**Re: Core Development Group / Marian Shrine
174 Filors Lane, Town of Haverstraw, NY**

SITE PLAN REVIEW DOCUMENTS FOR MARIAN SHRINE SOLAR ARRAY CORE DEVELOPMENT GROUP 174 FILORS LANE STONY POINT , NEW YORK 10980

Two-lot subdivision of a 131-acre parcel located in the R-25 zoning district. Site plan for a 5 MW, ground mounted community solar array, which is proposed for Lot 2 (37.91 acres). The existing structures on the site will remain on Lot 1 (93.09 acres). The site also includes a 29.72-acre parcel located in the Town of Stony Point. A special permit application has been concurrently submitted to the Town Board, as well as a variance application for street frontage from the Zoning Board of Appeals.

DRAWING TITLE
TREE REMOVAL PLAN

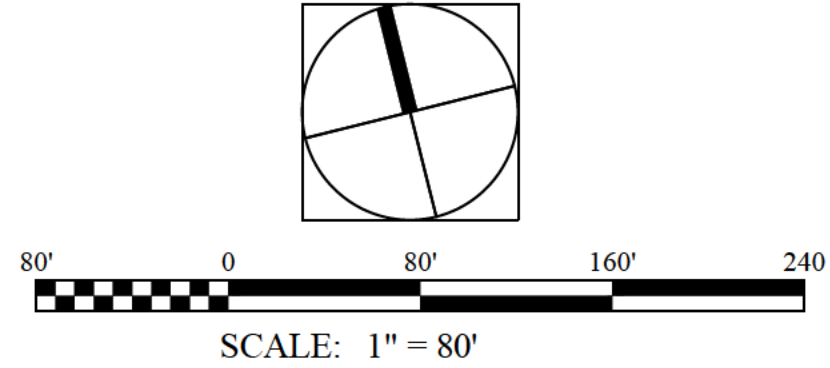
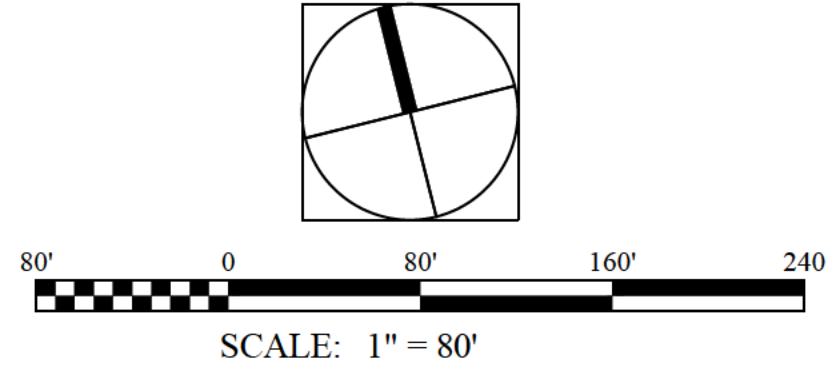
11 As discussed above, the subject site is heavily wooded with the application indicating that approximately 13 acres of trees will be cleared to build the community solar system. The Tree Removal Plan, Drawing C03, plots what appears to be the trees to be removed on only the eastern portion of the project, and neither the Subdivision Sketch nor the Tree Removal Plan, show the number and location of existing trees, as is required by Sections A176-17 and A176-18. This department recommends that the number, type, and size of trees be identified on the subdivision sketch and the site plan. We also bring to the Boards attention that the NYSERDA 'New York Solar Guidebook for Local Governments' recommends that the removal of existing trees larger than [6] inches in diameter should be minimized to the extent possible. Additionally, the applicant should provide a detailed analysis of how the solar array would be visually buffered from surrounding roads and properties.
